In reply please quote: DA 167.1/2023

PROPOSAL: CABRAMATTA EAST REDEVELOPMENT - DEMOLITION OF EXISTING BUILDINGS AND STAGED CONSTRUCTION OF A MIXED-USE DEVELOPMENT UP TO 19 STOREYS COMPRISING BASEMENT CARPARKING OVER WHICH WILL BE A NEW MARKET SQUARE, THREE BUILDINGS CONTAINING GROUND LEVEL RETAIL, FIRST LEVEL COMMERCIAL GFA INCLUDING A TAVERN, CHILDCARE CENTRE FOR A MAXIMUM OF 80 CHILDREN, GYMNASIUM, MEDICAL CENTRE AND RESTAURANT AS WELL AND 358 APARTMENTS ABOVE. THE DA ALSO SEEKS CONSENT FOR THE PUBLIC DOMAIN IMPROVEMENT AND SUBDIVISION (BY BOUNDARY ADJUSTMENT) TO INCORPORATE A SMALL SECTION OF THE EXISTING CUL DE SAC HEAD AT THE END OF THE PUBLIC LANE.

APPLICATION NO: 167.1/2023

Fig. 4 – Proposed Building Envelopes

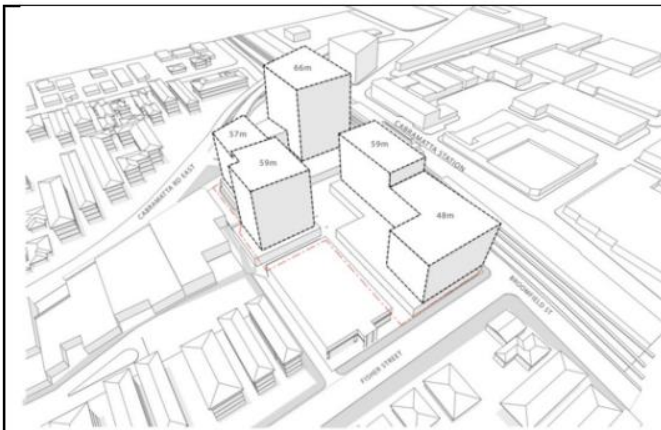
As part of the recent Planning Proposal for the precinct, a Site Specific DCP (SSDCP) was prepared in support of the increased Building Heights and additional FSR proposed. The SSDCP outlined a built form that included the location of buildings within the site, the heights of the buildings and a general building envelope for the whole precinct. The built form envisaged in the SSDCP was supported by Urban Design analysis/advice and this was also peer reviewed by Council. Accordingly, when the planning proposal was gazetted, the SSDCP was incorporated in the

Cabramatta Town Centre Development Control Plan No. 5/2000. The SSDCP seeks the built form of the precinct as per the following Figures:

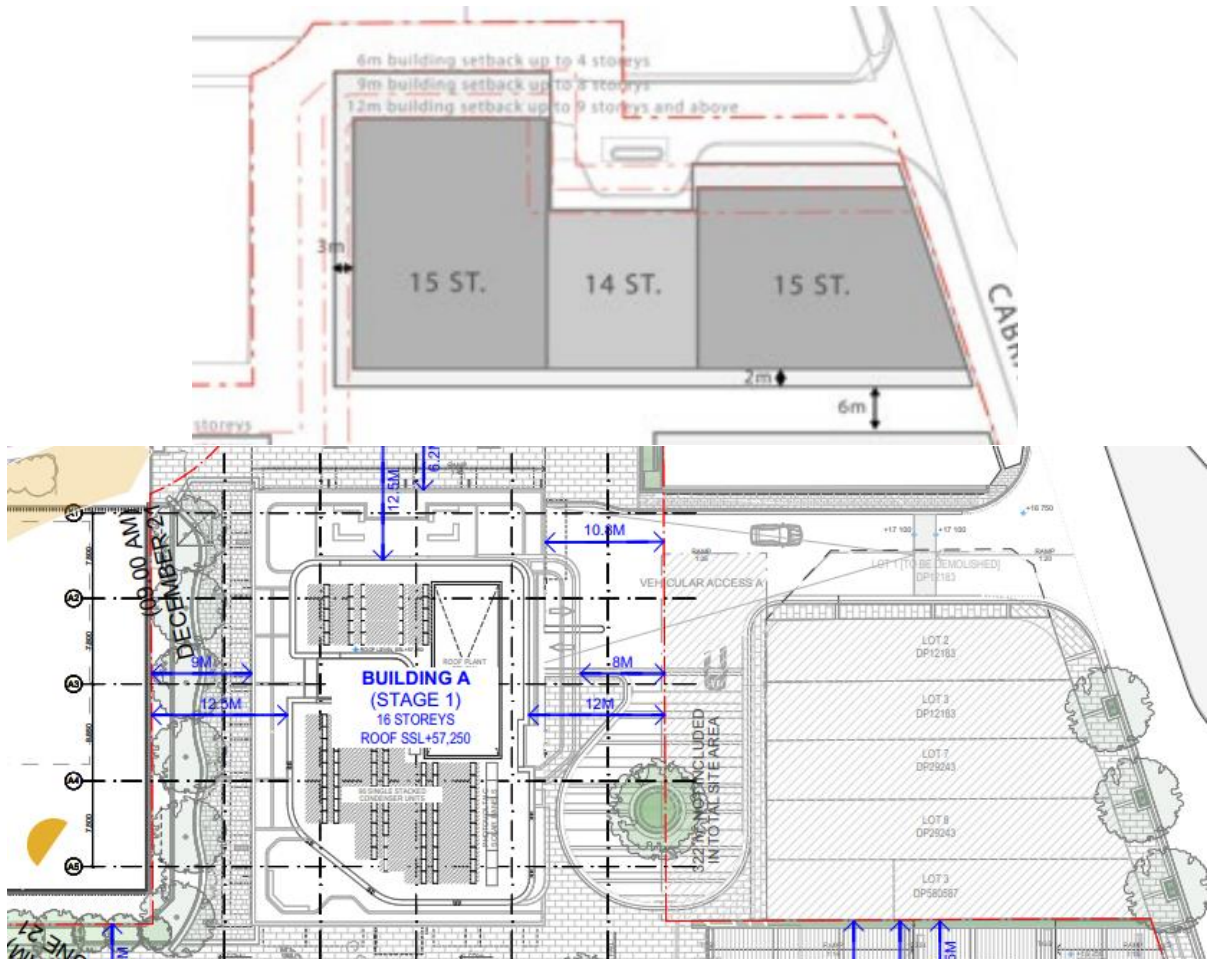
The following is noted about the differences between the SSDCP building footprint and master plan to that of the proposal.

- Building A is designed as an 18 – storey building (inclusive of the mezzanine) whilst the SSDCP permits only a 15 – storey building. The building is also designed in a way that would not allow for a 14 storey building that connects with Stage 3. This is described in the figures below:

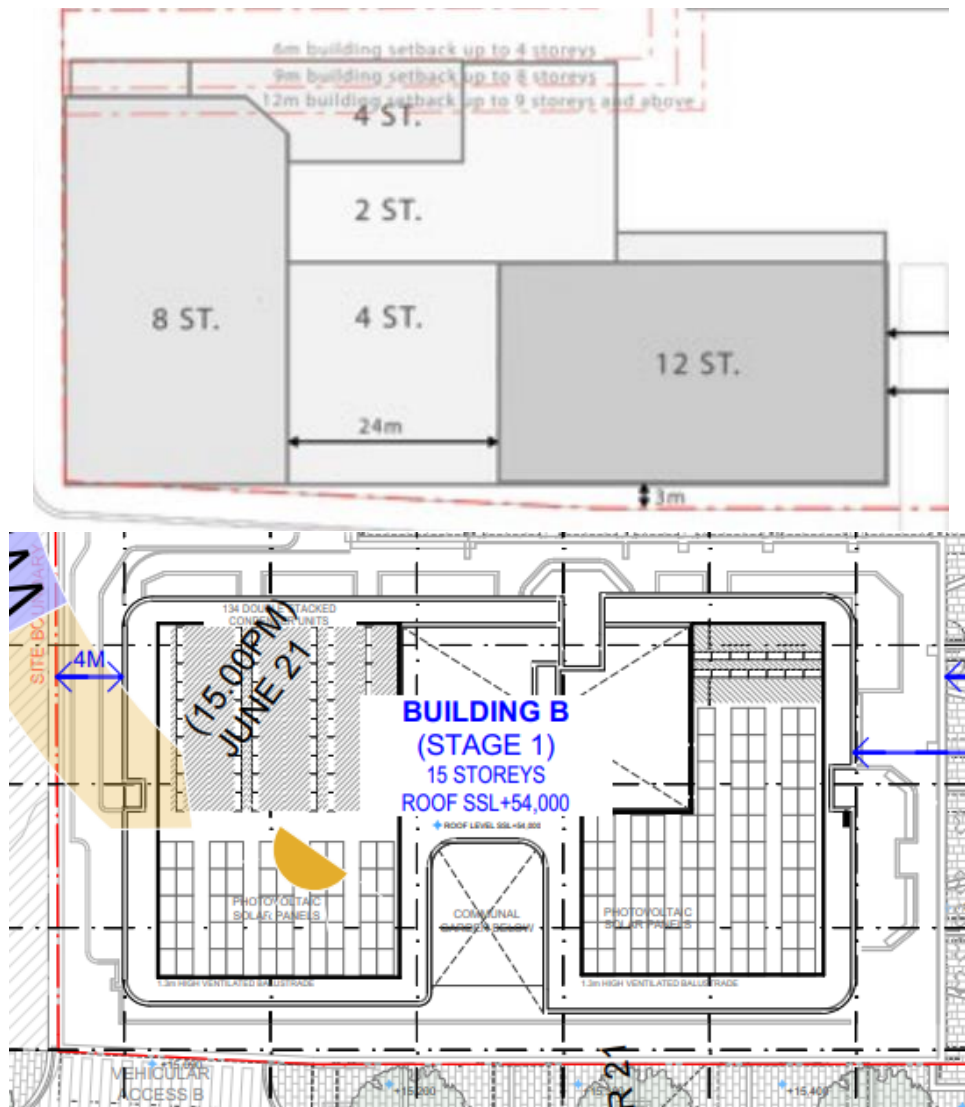
- Building B is designed as a 16 – storey building whilst the SSDCP permits a 12 storey building. The building is also designed in a way that would not allow a connection to a part 2 and 4 storey building in Stage 4. Furthermore, it is designed with openings and units facing the northern boundary of the site with only a 4m setback and therefore would not comply with the building setbacks required by the Apartment Design Guidelines. This is indicated in the figures below:

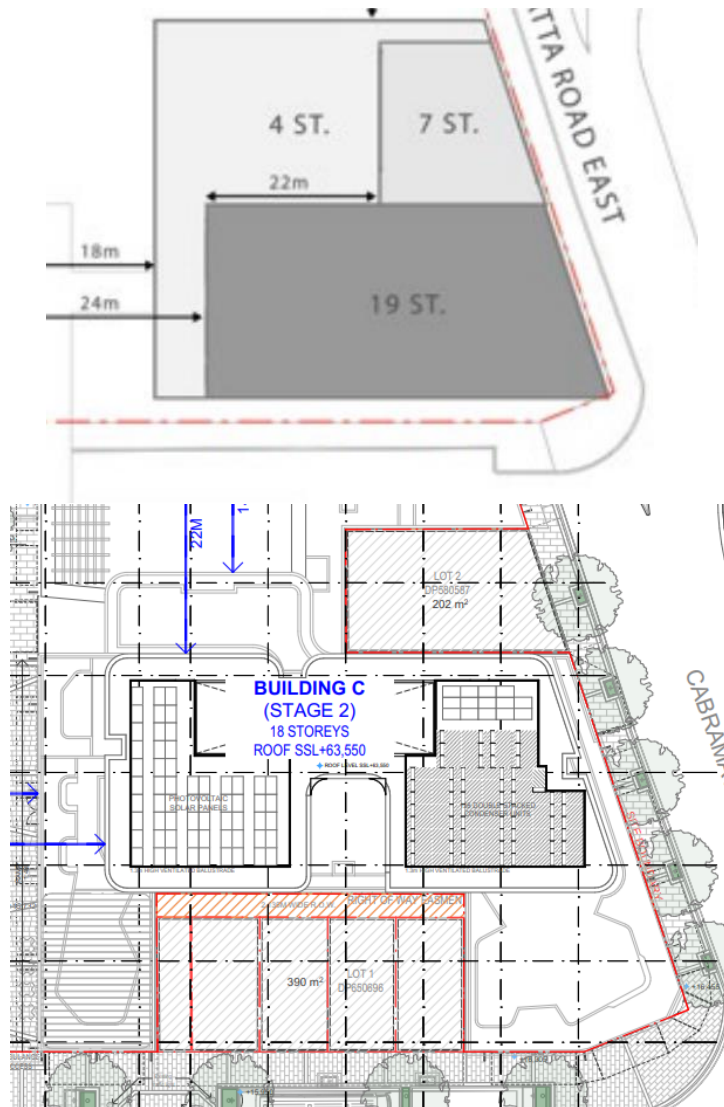
- Building C is not consistent with the built form envisaged in the SSDCP. The original master planning sought to create a precinct by creating a significant landmark as a “gateway”. The building was comprised of a part 19 and 7 storey tower at the intersection of Broomfield and Cabramatta Road East that sits on a 4 storey podium. As discussed above, given that not all the lots have been included in Stage 2 the 19 storey development has been shifted and now presents as a tall skinny building perched on a low dominant podium. Furthermore Tower C includes openings and balconies up to the boundary which is inconsistent with the Apartment Design Guidelines. This is expressed in the figures below:

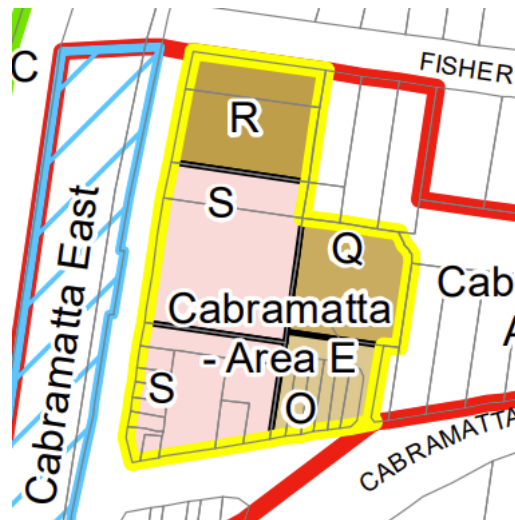
The proposed inconsistencies with the built forms as depicted in the SSDCP have resulted in the following issues:

- Given the design of Tower A and B, Stages 3 and 4 are unable to be developed in accordance with the SSDCP.
- There are additional storeys proposed on Towers A and C and Tower C has been relocated. The overshadowing impacts are therefore different including the impacts to the rest of the stages within the precinct and the southern neighbours including the residential flat building across Cabramatta Road.

- Tower B and C has been located closer together which has narrowed the pedestrian link between Cabramatta Train Station and the Market Square.
- The amount of Communal Open Space and potential deep spoil in Stage 1 has been reduced.

- Tower B has a setback of 4m from the northern boundary which does not comply with the minimum setback required in the Apartment Design Guidelines.
- Tower C has a nil setback to the isolated/excluded lots which does not comply with the minimum setback required in the Apartment Design Guidelines
